## **ADDENDUM NO. 2**

Project: NDOT – District 1 Superior St ADA Renovations

Issued: December 27, 2023

**AD2.1**                      Drawing Sheet A100: See the attached sheet showing dimensions of solid surface countertops.

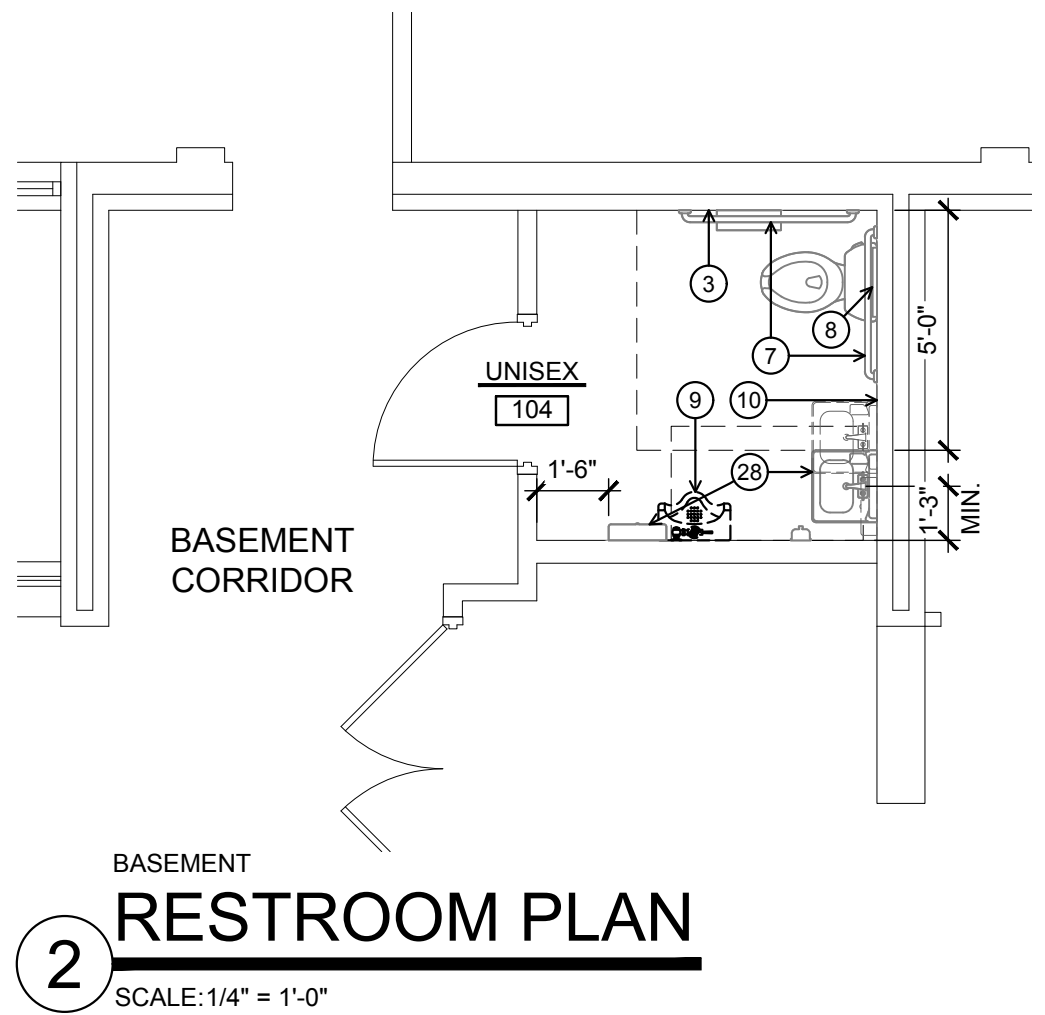
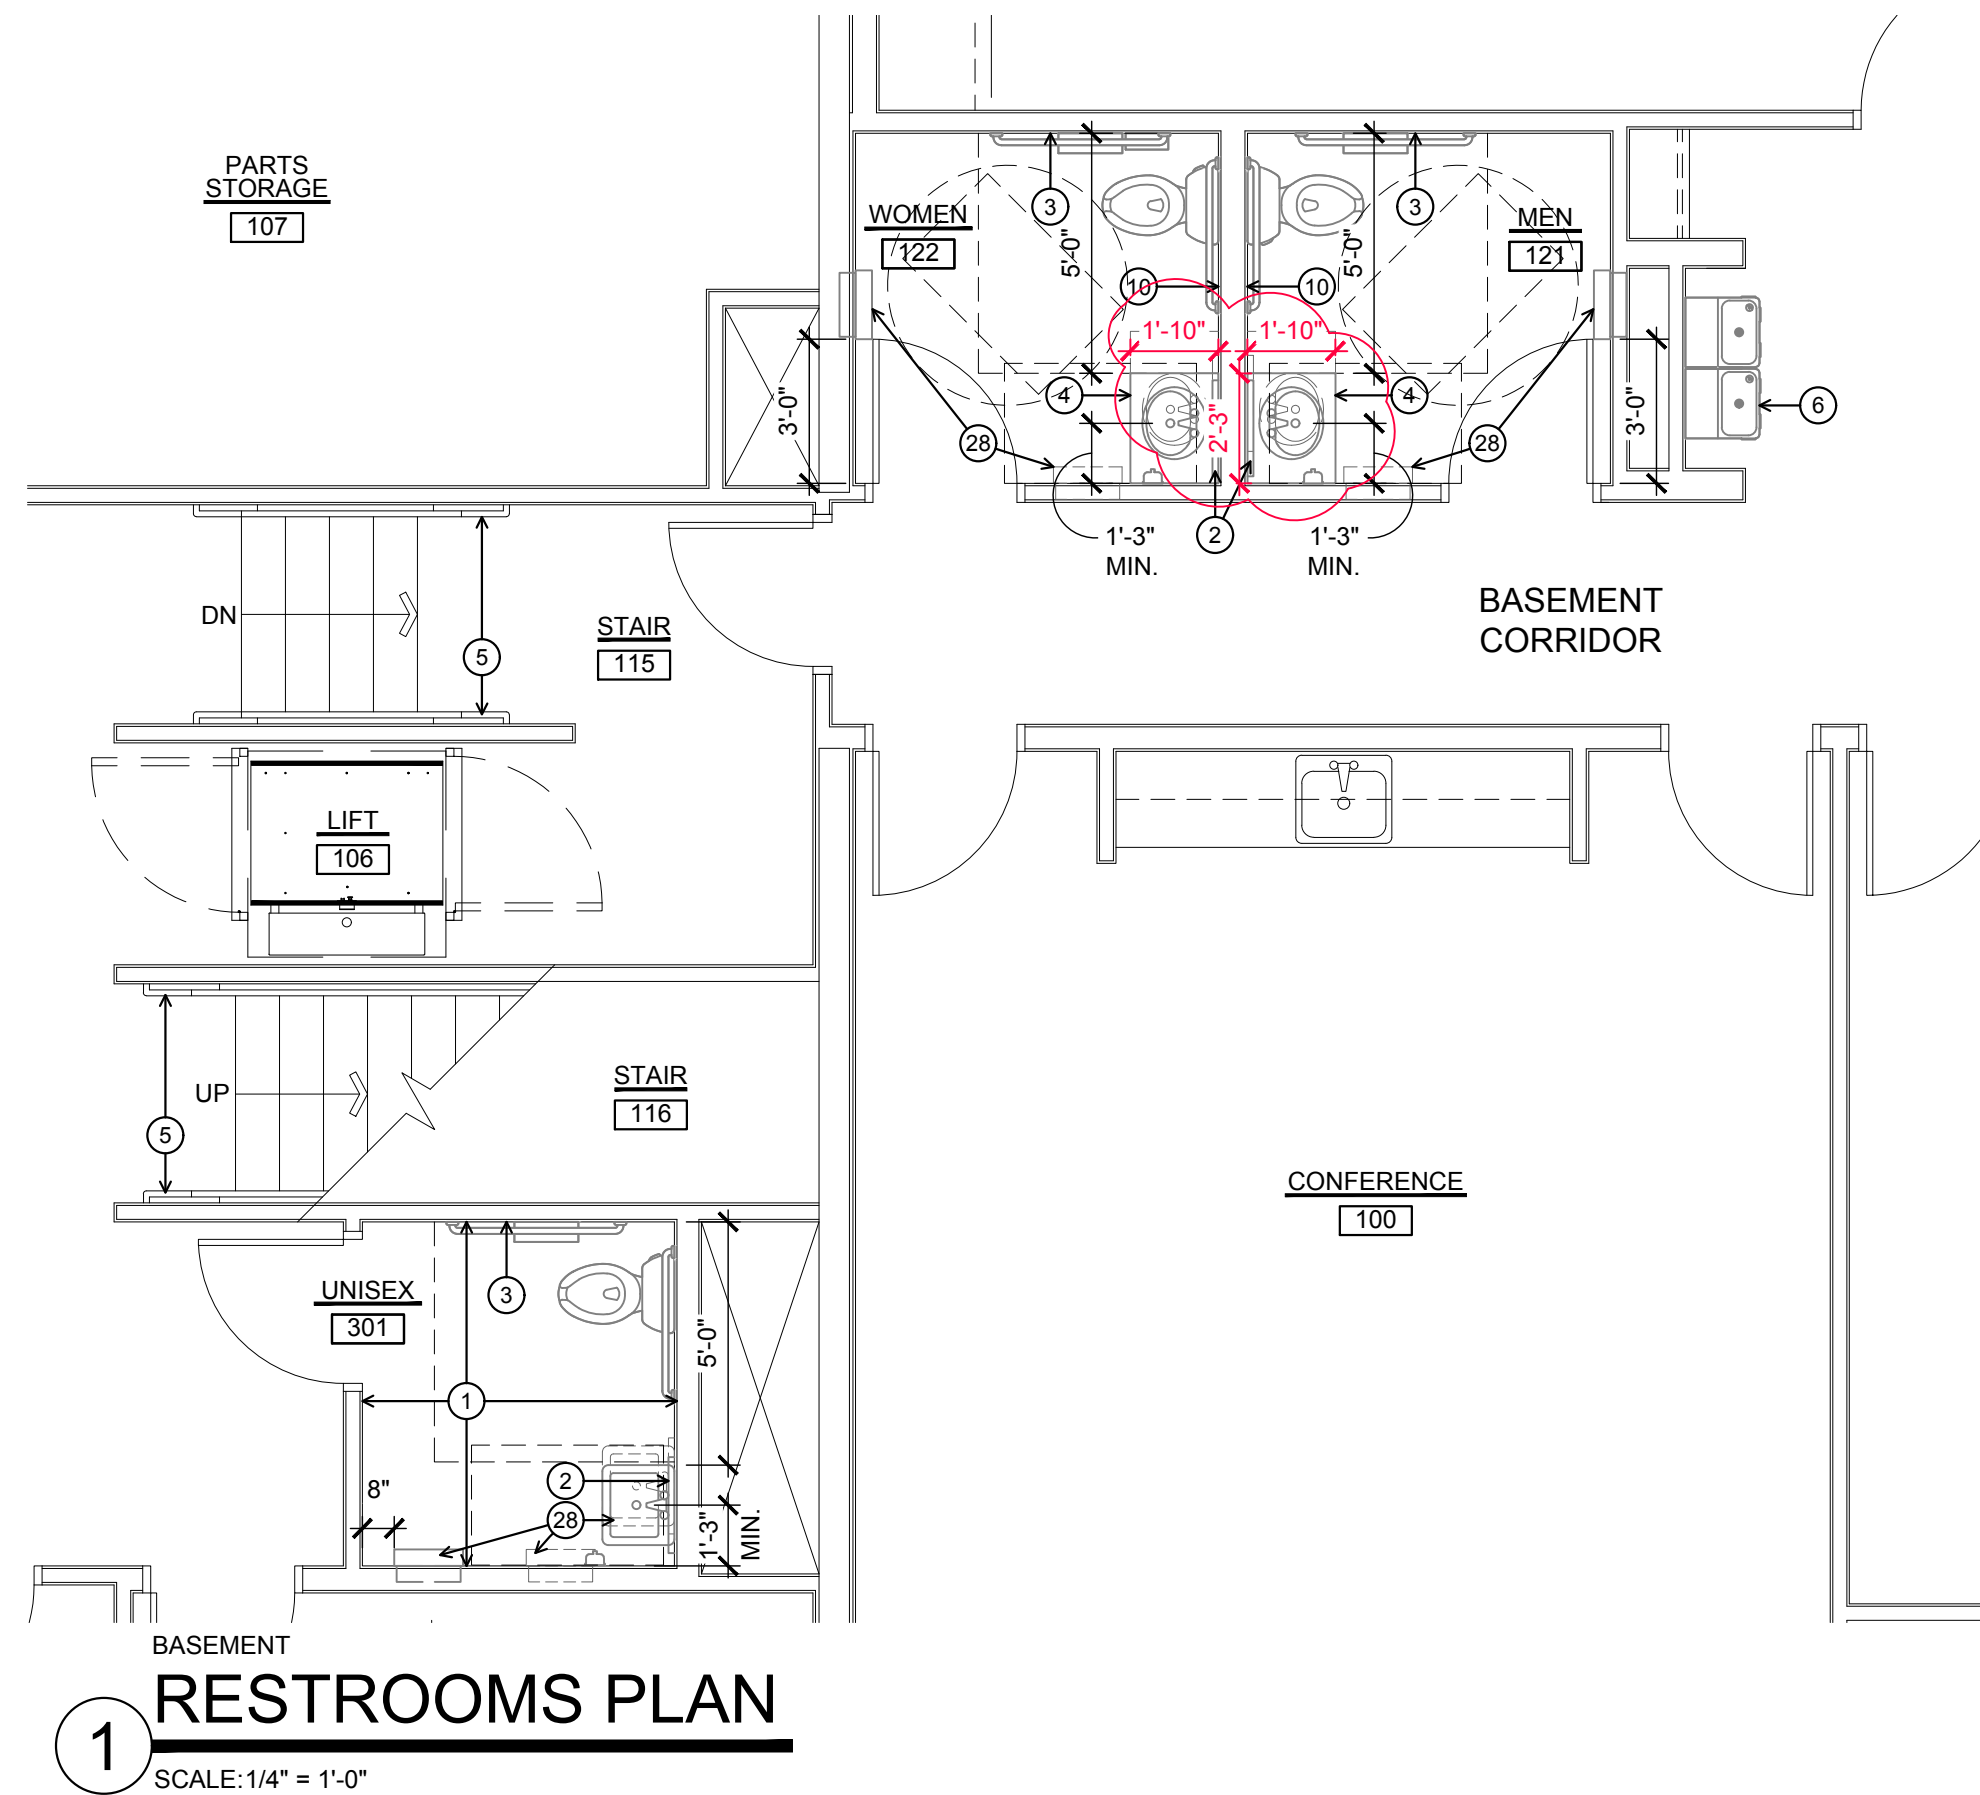
**AD2.2**                      Clarification: Backsplash for solid surface counters shall be integrated cove backsplash.
